**PLANNED UNIT DEVELOPMENT
& SUBDIVISION STAFF REPORT**

DEVELOPMENT NAME South China Subdivision

LOCATION 3831 Airport Boulevard
(South side of Airport Boulevard, 625'± East of
Downtown Loop West)

CONTEMPLATED USE Planned Unit Development Approval to allow shared access and parking between two building sites, and Subdivision Approval to create two legal lots from three metes and bounds parcels.

SITE PLAN

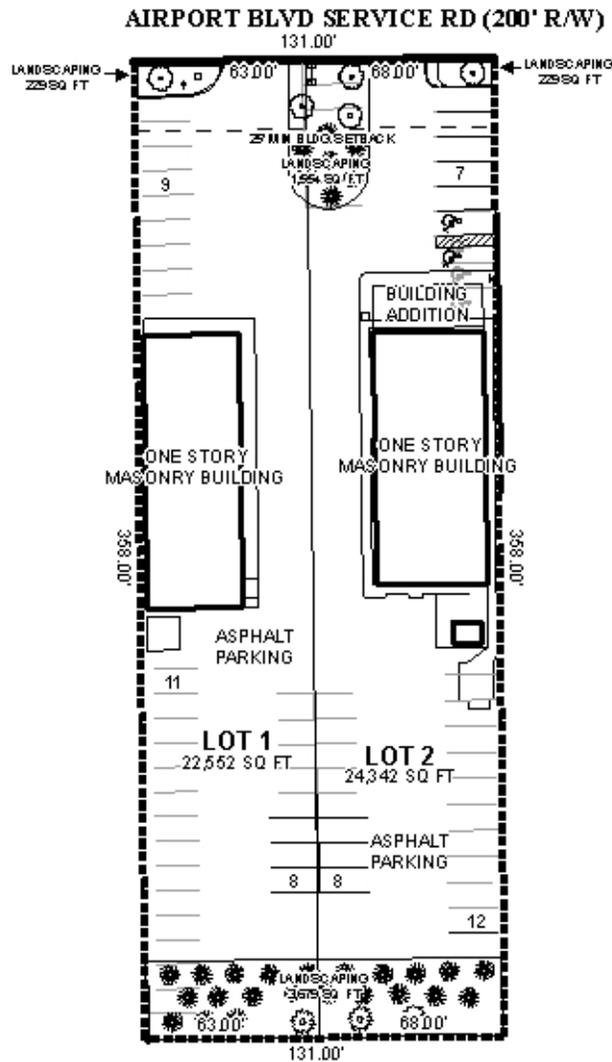
COMMENTS Driveway number, size, location, and design to be approved by Traffic Engineering and conform to AASHTO standards. The parking area on the northeast side of the lot does not have adequate parking aisle width. A minimum of twenty-four feet aisle width is required for ninety degree parking spaces. Standard widths for one-way drives are between fourteen and sixteen feet. The two driveways shown exceed the maximum allowable width. Changes should be made to accommodate the standards. One way drives should be signed and marked.

Regarding the PUD, the site plan submitted indicates an existing 3,500 square foot retail building requiring 12 parking spaces on Lot 1 and an existing 3,730 square foot restaurant requiring 38 parking spaces on proposed Lot 2. The site plan submitted indicates all property line setbacks to be compliant, and site coverage is determined to be compliant due to the site coverage calculations given. It should be noted that the site plan indicates a 680 square feet, 17-foot x 40-foot expansion proposed for the restaurant, which would require an additional seven parking spaces for a total requirement of 57 spaces, only 55 are illustrated of which two are located on the clean out of the grease traps.

Internal circulation and parking is indicated; however, areas for truck loading/unloading, if any, are not indicated. The existing curb cuts to Airport Boulevard are shown to remain. Parking calculations are provided based on the square footage of each use of the buildings, the calculations are not correct based on the existing uses of the buildings and landscaping areas and tree plantings are shown and calculations provided that comply with the landscaping and tree requirements of the Ordinance.

No storm water detention area is indicated, but no verification is furnished that such would not be required. No dumpster is depicted on the site plan.

If a dumpster is utilized, it should be depicted on the site plan, or a statement should be provided indicating that no dumpster will be included as part of the development.

- 1) submission of revised site plan illustrating the location of the dumpster(s) with proper screening, corrected parking ratio calculations for each building use, and correction of the number and location of required parking spaces;
- 2) submission of elevation drawing indicating the addition and its relation to the East side yard property line;
- 3) parking location should be revised to illustrate no parking stalls located on the clean out areas of the grease trap;
- 4) compliance with the conditions of Traffic Engineering; and
- 5) provision of compliance with Sections 64-4.2 and 64-4.A.3.C of the Zoning Ordinance.
